APPENDIX G. COMMENTS RECEIVED ON THE FINAL SEIS AND RESPONSES

NEW SUBSTANTIVE COMMENTS AND RESPONSES

Appendix G.1 New Substantive Comments

Engineer warns IBR's planned S-curve approach will create deadly conditions worse than San Francisco's accident-prone detour. Photo courtesy Interstate Bridge Replacement Program

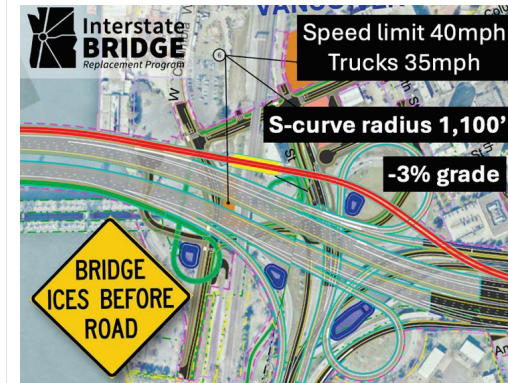
I believe the Interstate Bridge Replacement design will be extremely dangerous and will require a low speed limit.

The IBR plans a permanent S-curve on the Vancouver bridge approach that will have a tighter radius of 1,100 feet, also have a -3% grade, and have only 200 frost-free days, resulting in frequent icy conditions. This perfect storm of conditions will make IBR's S-curve much more dangerous than the Bay Bridge's deadly record. Cool air circulating on both top and bottom of the road deck will freeze fog and rain on the north-facing bridge approach. A northbound car or truck may drive up an ice-free Hayden Island approach, its south-facing roadway melted by the sun's radiation. Cresting the bridge at 60 mph, a driver may hit black ice on the S-curve with a -3% grade. It will be almost impossible for a semi-truck to avoid jackknifing. Vancouver residents can only pray that the first truck to fly off the bridge is not a gasoline tanker.

The IBR has not yet set a speed limit for its planned bridge, but with its extremely tight S-curve and possible icy roadway, anything over 40 mph and 35 mph for trucks will be considered engineered manslaughter.

Figure 2. Route #60 from downtown Vancouver, across the I-5 bridge to the Max Yellow Line station at Delta Park, with stops at Jantzen Beach shopping area at certain times.

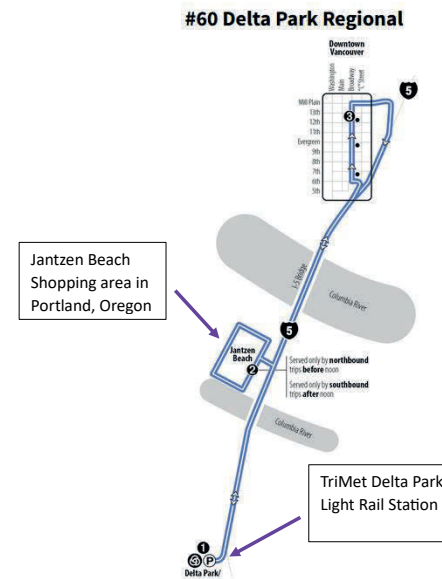
Light rail would merely replace Route 60 to connect to the existing Max Yellow Line at Delta Park (see Figure 2). That number has stagnated at about 900 bus boardings, or about 450 people, if round trips.

Light rail is expected to cost about \$3.5 billion out of the \$14.4 billion total (up to [\\$17.7 Billion](#) or more), or about 24% (April 21 2026 C-TRAN Board meeting). That is a ridiculous amount to spend to benefit very few people whose needs are now met by a single bus route.

Figure 3. Comparison of weekday C-TRAN bus boardings for 2006, 2018-2026, and IBR 2045 forecast for both light rail and buses.

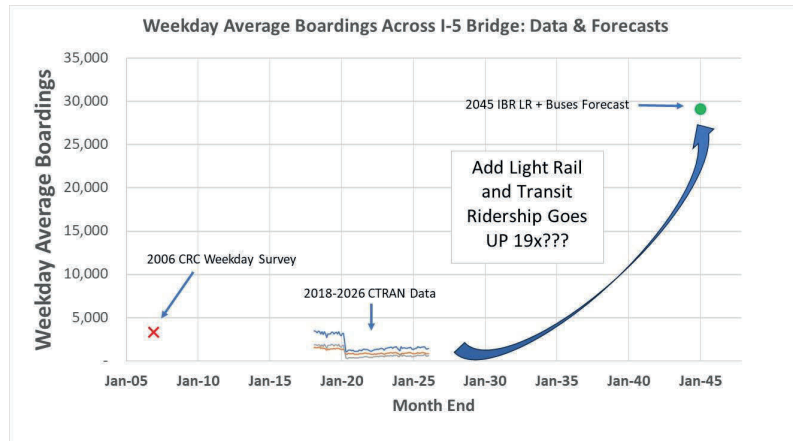
Forecasts for 2045 made by IBR expect unreasonably explosive growth in transit ridership, ~19x. (FSEIS Executive Summary, Table 3, p S-18).

Figure 3 compares the bus boardings for 2006, 2018-2026, and the IBR 2045 forecast for both light rail and buses. IBR forecast numbers are given in Table 3 below.

Figure 2-18. Typical Cross Section of the Single-Level Fixed-Span Configuration (Girder Type)

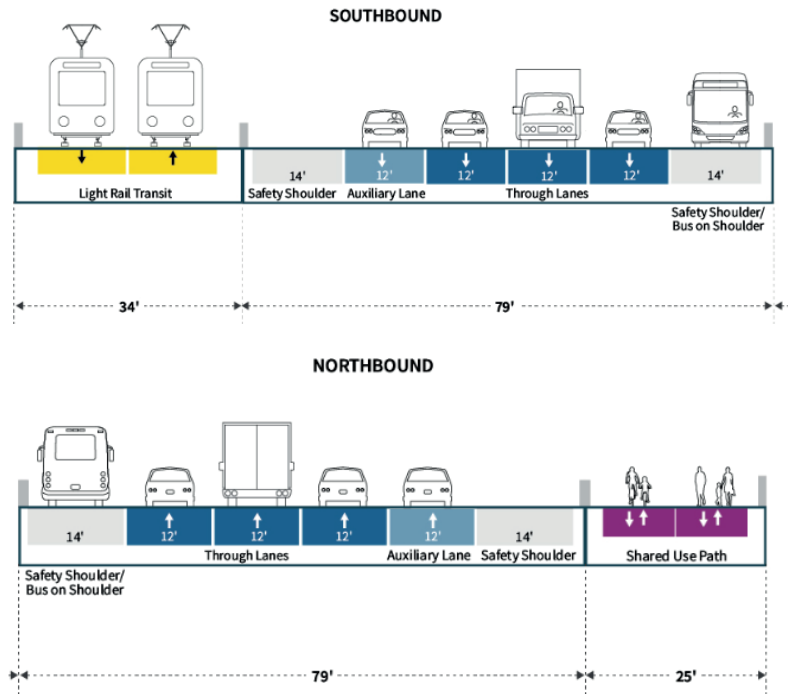
3) IBR bridge design allocates far too much space for transit, pedestrians, and bicycles, while severely short-changing cars, trucks, freight, and emergency vehicles.

Traffic lanes - 12 ft wide, Light Rail - 34 ft (almost 3 traffic lanes), Bus-on-Shoulder - 2x14 ft = 28 ft (over 2 traffic lanes), Pedestrians and Bicycles - 25 ft (2 traffic lanes). Cars, trucks, freight, and emergency vehicles are restricted to 3 through lanes and 1 Auxiliary lane each direction.

Figure 5. 2019 Existing Conditions for various modes of transportation across the I-5 bridge, along with IBR planned lane space allocations. Data: Table 4-7 from [Transportation Technical Report](#), p 2-26.

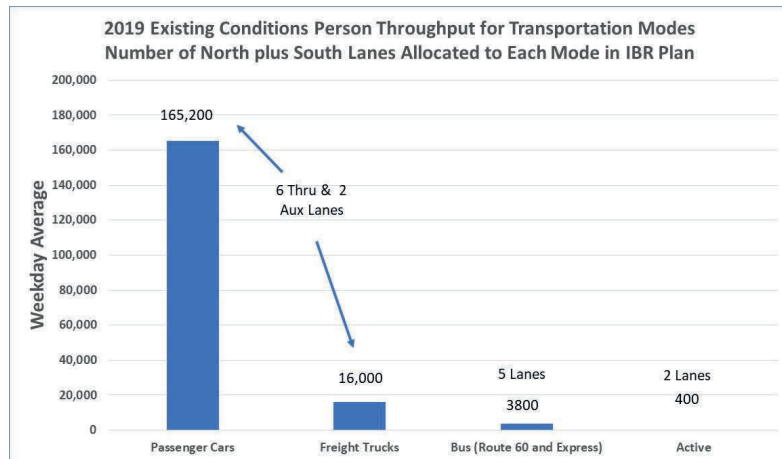
In the bar chart of Figure 5 below I compare 2019 Existing Conditions for Person Throughput from Table 4-7 for different transportation modes. Also indicated are the approximate total number of lanes (both north and south) which the IBR design proposes for each mode.

Figure 6. 2045 Prediction of person throughput for various modes of transportation across the I-5 bridge, along with IBR planned lane space allocations. Data: Table 4-7 from [Transportation Technical Report](#), p 2-26.

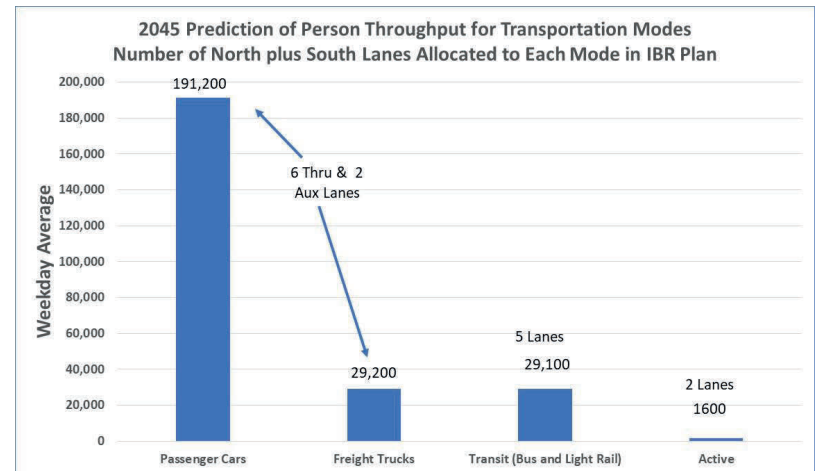
In the bar chart of Figure 6 below I compare 2045 forecasts for various modes. Even assuming the IBR’s unrealistic 2045 forecasts, the distribution is still extremely unreasonable.

Passenger cars and freight make up 88% of usage, but are crammed into 3 Thru lanes and 1 Auxiliary lane in each direction, while 3.5 lanes each way are allocated to only 12% of users.

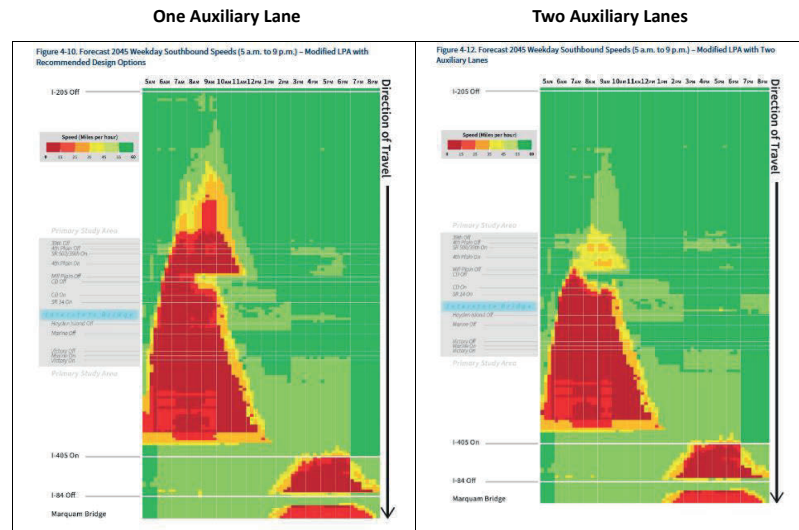
Visual comparisons of predicted speeds for the two models along the I-5 corridor are shown below. 2045 weekday southbound speeds are shown for the IBR Recommended Design (with One Auxiliary lane) in Figure 4-10. The vertical scale is location along I-5 and horizontal scale is time of day. Colors indicate traffic speed: Red is the slowest and green the fastest. Speeds are slowest in the AM, and much faster in the PM. Source: pp 4-33ff of the [Transportation Technical Report](#).

Speeds for the IBR Recommended Design with One Auxiliary lane (Figure 4-14, left side) are compared to the design with Two Auxiliary lanes (Figure 4-16, right side).

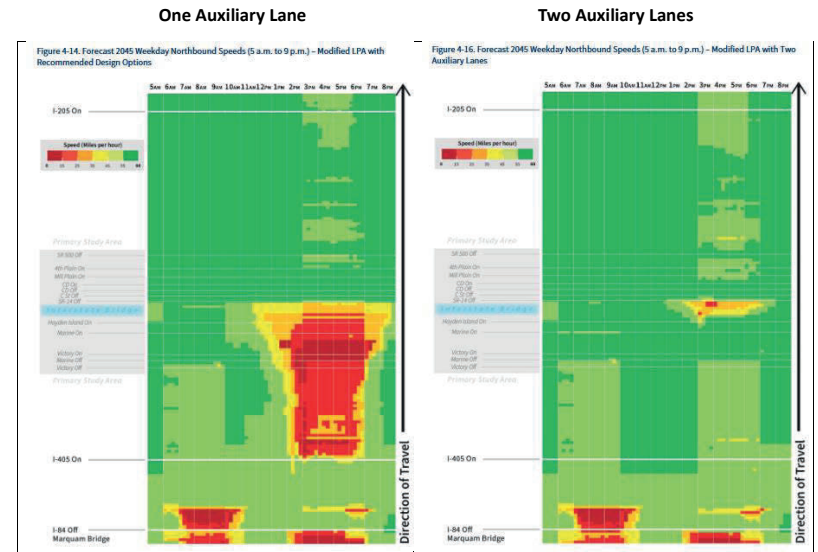
Forecast 2045 Northbound: Speeds are much faster during PM rush hour for the Two Auxiliary lane option. A dramatic increase in speed in the afternoon is apparent, with limited slow downs at the I-5 bridge.

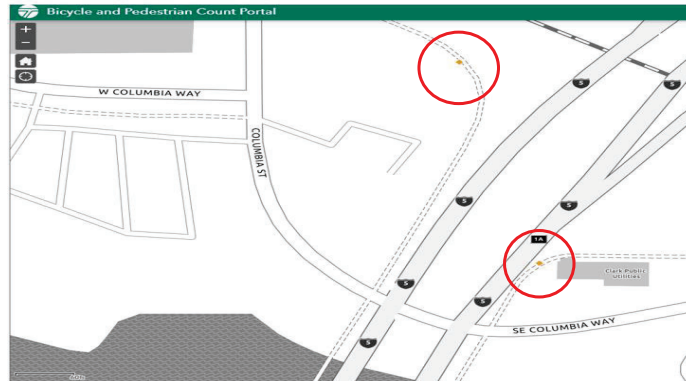
*Concerns: A single count of bicyclists & pedestrians, Oct. 19, 2022, is shown in DSEIS and FSEIS as the basis for annual average weekday bicycle and pedestrian activity

The single day observed was not typical, it was smoky. Smoky days are few per year. The count was inflated from 296 up to 410 based on literature on a smoke event in Seattle, which is not reasonable. The IBR project began in 2019 and the FSEIS was published on April 17, 2026.
